TRANS/WP.30/2000/14/Add.1/Corr.1
20 June 2000

**CUSTOMS CONVENTION ON THE INTERNATIONAL TRANSPORT OF GOODS
UNDER COVER OF TIR CARNETS (TIR CONVENTION, 1975)**

Validity of curtain-sided vehicles

Addendum 1

SHEET GUIDANCE AND OVERLAP - TOP

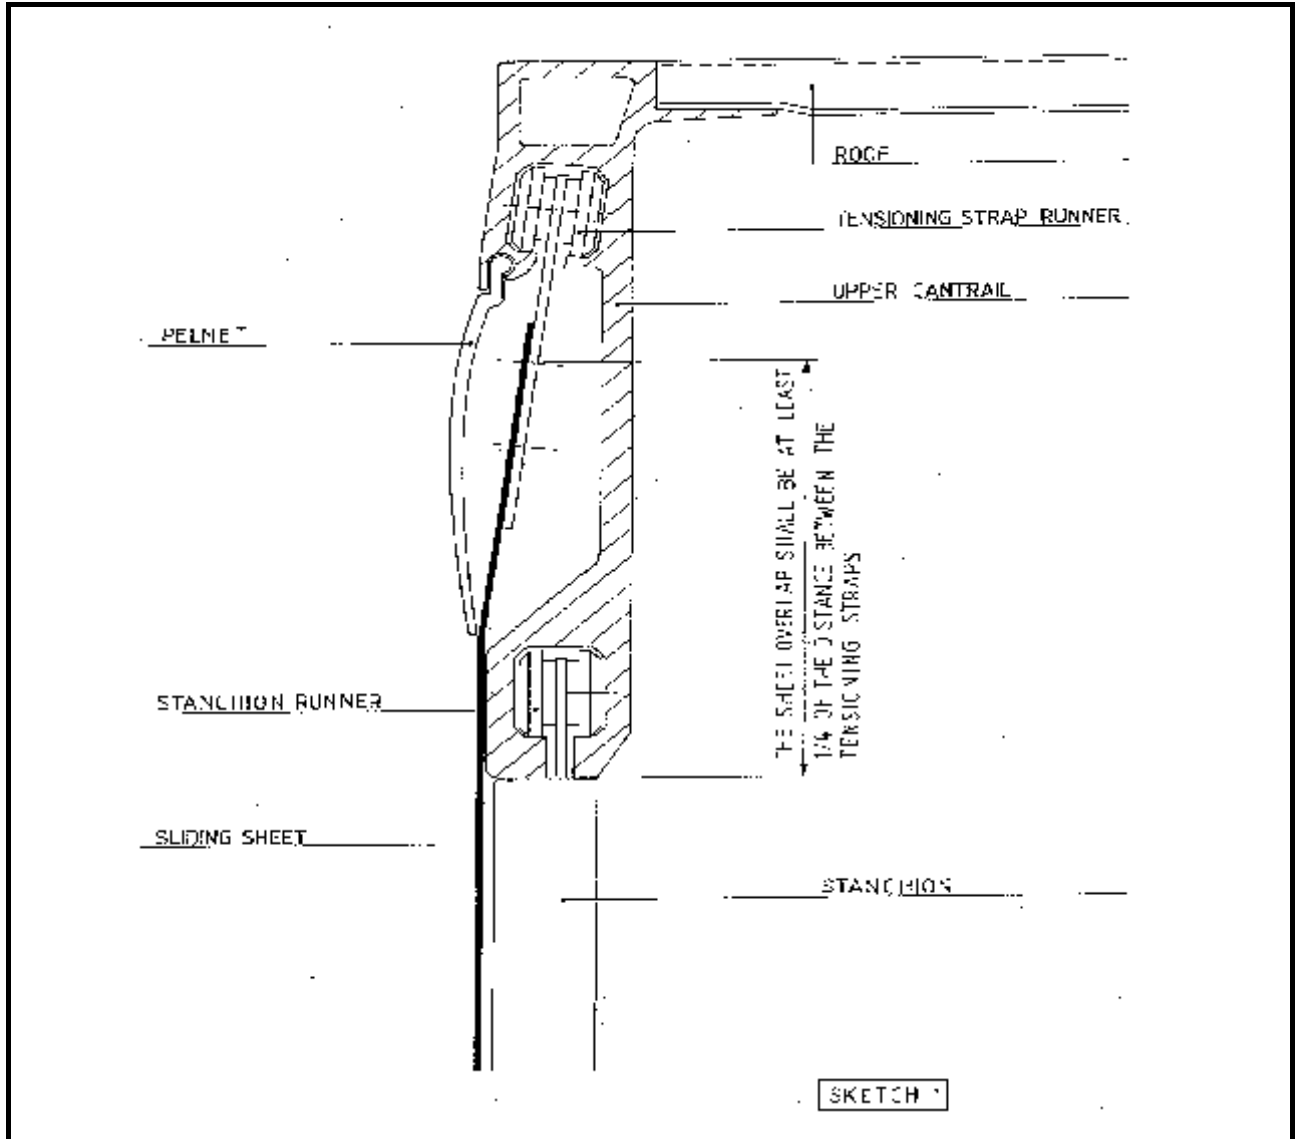
Add the following sentence after the last sentence of Annex 2, new Article 4, paragraph 2 (iii):

“The system is described in sketches No.10 and No 11 appended to this Annex.”

Add the following new sketches to the existing sketches appended to Annex 2:

“The sheet shall overlap the solid parts at the top of the vehicle by at least $\frac{1}{4}$ of the actual distance between the tensioning straps. The sheet shall overlap the solid parts at the bottom of the vehicle by at least 50 mm.”

SHEET GUIDANCE AND OVERLAP - TOP

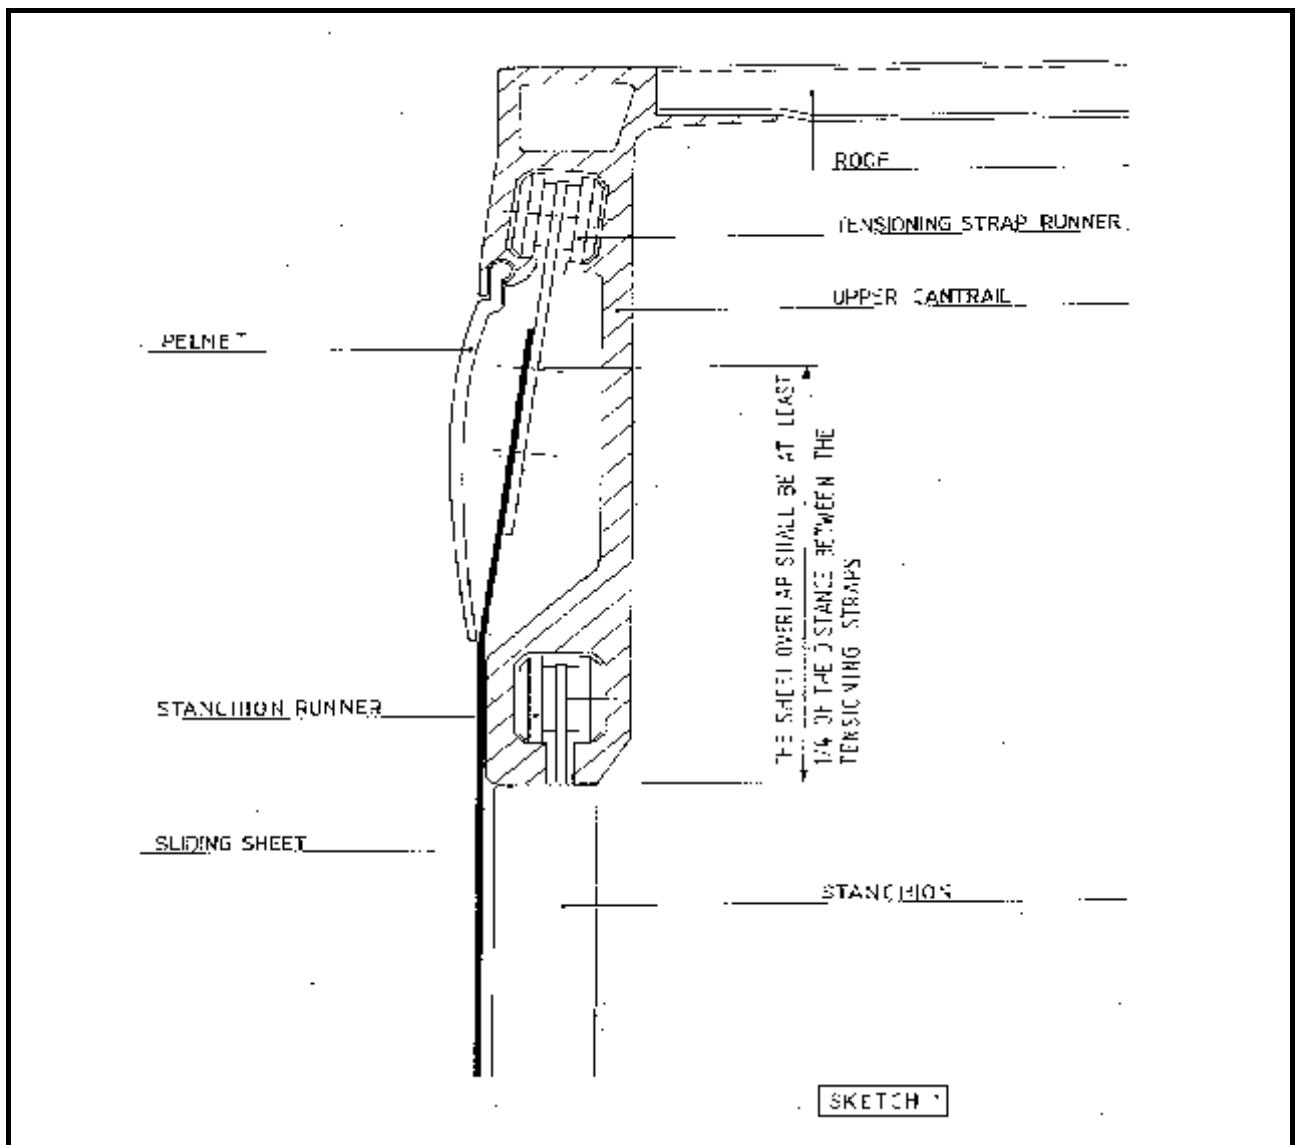
Add the following sentence after the last sentence of Annex 7, new Article 5, paragraph 2 (iii):

“The system is described in sketches No.10 and No. 11 appended to this Annex.”

Add the following new sketches to the existing sketches appended to Annex 7:

“The sheet shall overlap the solid parts at the top of the vehicle by at least $\frac{1}{4}$ of the actual distance between the tensioning straps. The sheet shall overlap the solid parts at the bottom of the vehicle by at least 50 mm.”
